**ADDENDUM #1**

**TEMPLE WRF SEPTAGE RECEIVING STATION  
CITY OF TEMPLE, GEORGIA**

**HRC PROJECT H11148**

**TODAY'S DATE: February 17, 2012**

GWINNETT COUNTY  
DEPARTMENT OF PLANNING & DEVELOPMENT  
STANDARD DRAWING  
OUTLET CONTROL STRUCTURE  
TRASHRACK DETAILS  
DATE: NOVEMBER 2002

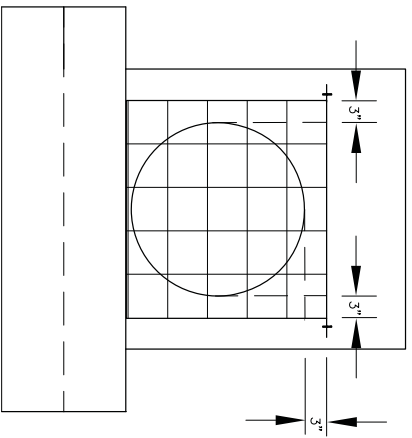
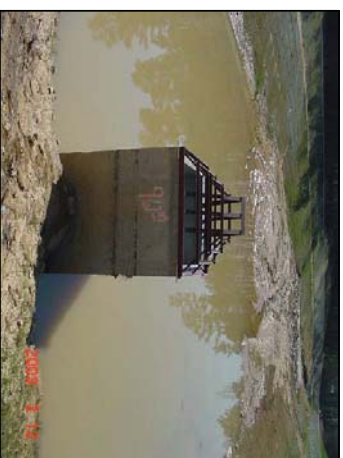
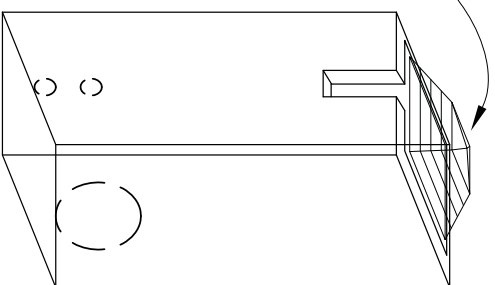
3. TYPICALLY TRASH RACK DETAIL IS PROVIDED. THE GO-BY DETAIL IS FROM GWINNETT COUNTY GEORGIA DETAIL #628 (ORIFICE DETAIL). CONTRACTOR WILL BE ALLOWED TO SUBMIT ALTERNATIVE TRASH RACK MEETING THE SPECIFIED DETAIL REQUIREMENTS.

REMOVABLE TRASH RACK WITH ACCESS DOOR  
BOLT TO OUTLET BOX  
SUBMIT DWGS. FOR REVIEW BY ENGINEER
